# 1109.2.3

## Accessible Lavatories

**CHANGE TYPE:** Modification

An accessible lavatory must be available to all users

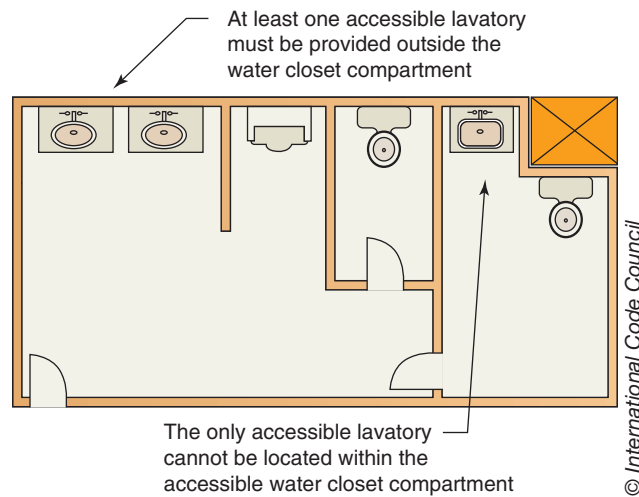
**CHANGE SUMMARY:** In order to prevent the placement of the only accessible lavatory within an accessible stall where it would not be available to all users, the required accessible lavatory must now be located in a common area of the toilet room or bathing facility.

**CHANGE SIGNIFICANCE:** To ensure that the accessible lavatory is available to all users of the toilet room at any time the room is open, it is now stated that an accessible lavatory must be located outside of a water closet compartment. If the only accessible lavatory is placed within one of the toilet compartments (including the wheelchair-accessible compartment), then others in the bathroom would not have access to that lavatory when the stall is in use.

The modification does not prevent the inclusion of an accessible lavatory within the accessible water closet compartment, but it would simply mandate that at least one accessible lavatory be located where it is available without going into a water closet compartment. The A117.1 standard is conceptually equivalent in regard to the turning space within the restroom. Section 603.2.1 of the standard prohibits the required turning space from being located within a toilet compartment. Including this requirement in the code coordinates the IBC with the requirements found in Section 213.3.4 of the ADA.

**2015 CODE: 1109.2.3 Lavatories.** Where lavatories are provided, at least 5 percent, but not less than one, shall be accessible. Where an accessible lavatory is located within the accessible water closet compartment at least one additional accessible lavatory shall be provided in the multi-compartment toilet room outside the water closet compartment. Where the total lavatories provided in a toilet room or bathing facility is six or more, at least one lavatory with enhanced reach ranges shall be provided.
